Product/Process Change Notice (PCN)

PCN Number: PCN_AbsEEL_20250505

Affected Series: WE-EEL

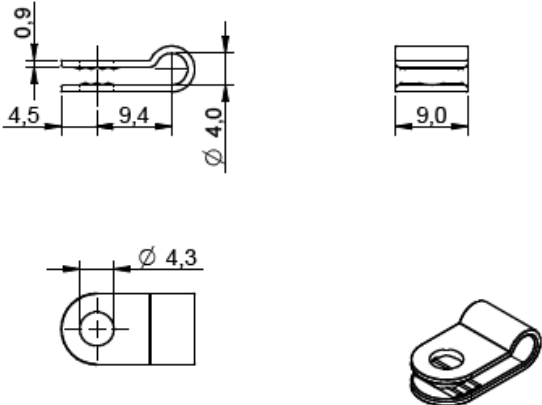
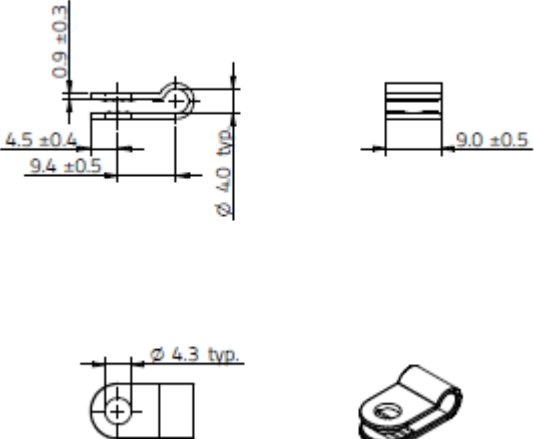
The tolerances and dimensions shown on the datasheet have been corrected.
